VILLAGE OF ORLAND PARK, ILLINOIS

2011 Road Improvement Program

Addendum #1

May 17, 2011

Palos Springs & Offsite Underdrain		
SCALE: 1"=100'	2011 Road Improvement Program	DRAWN BY: RJR
DATE: 5-13-11	Village of ORLAND PARK	REVISED: RJR
Public Works Department		DRAWING NO. 4 OF 7

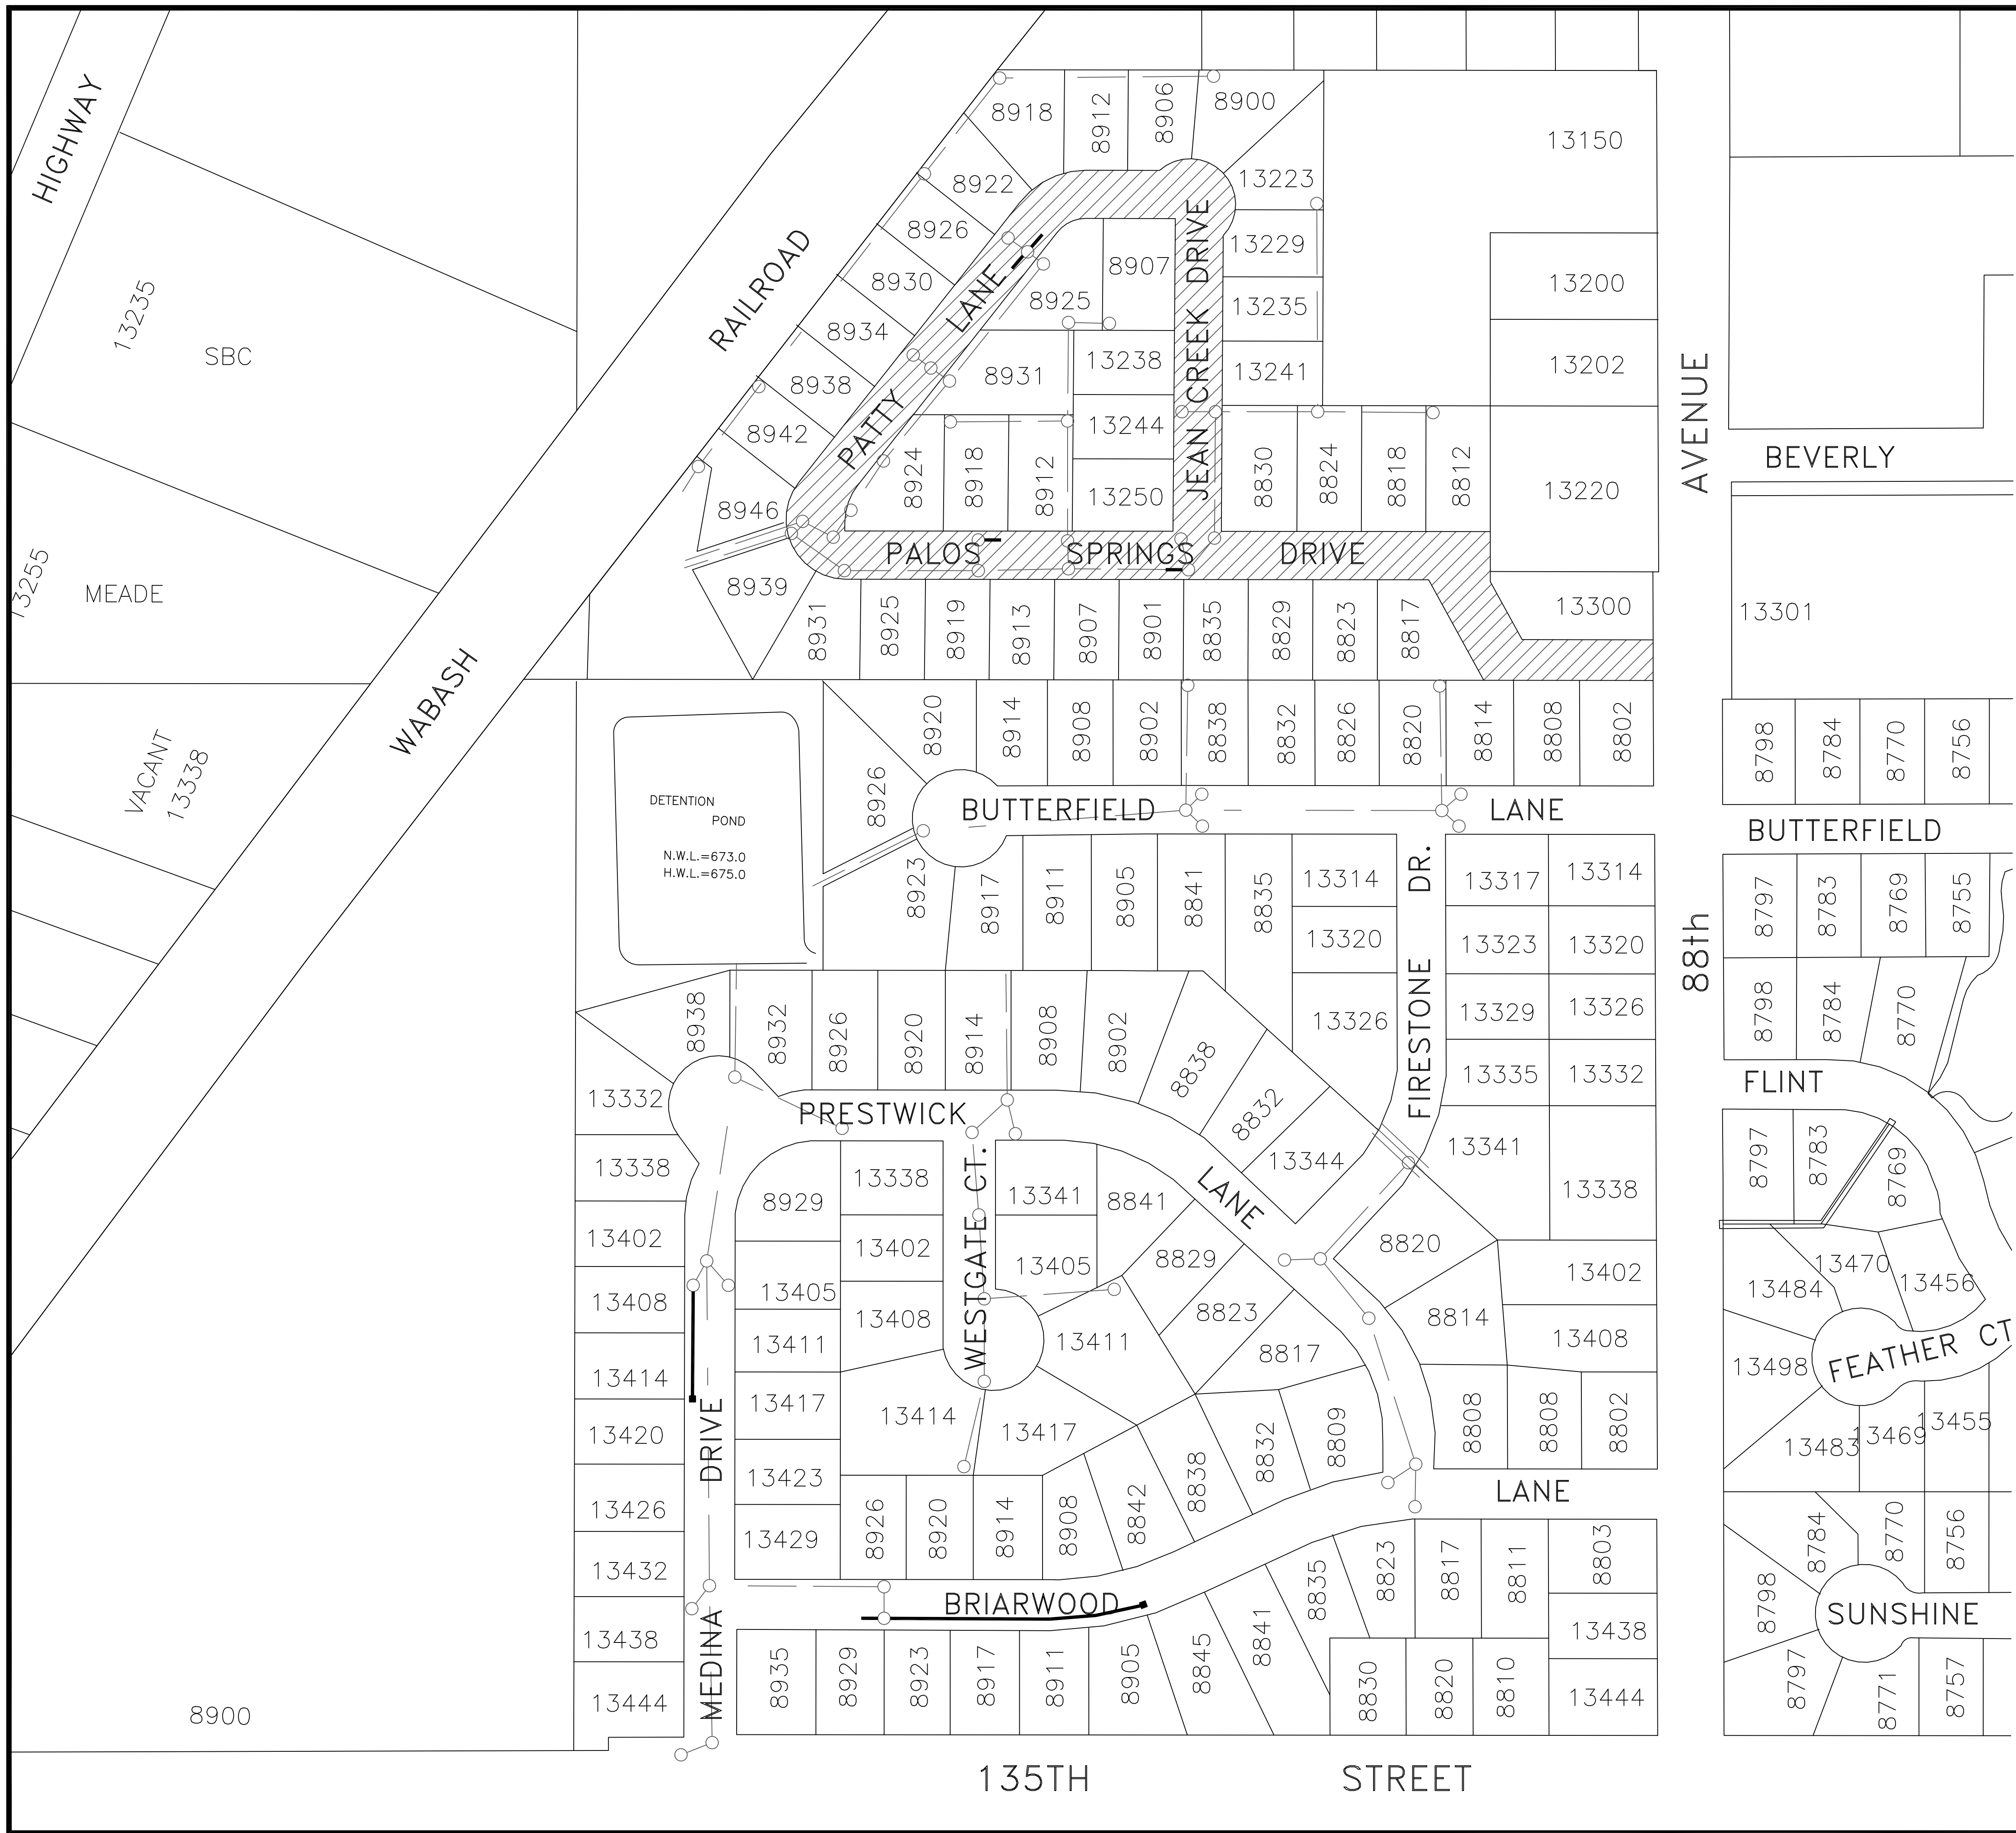
Revised Page 4 of 7 of Plan Set – Quantity List has been updated
(clarification only - no impact on bid amount)

Revision: Updated Quantity List 5-17-11
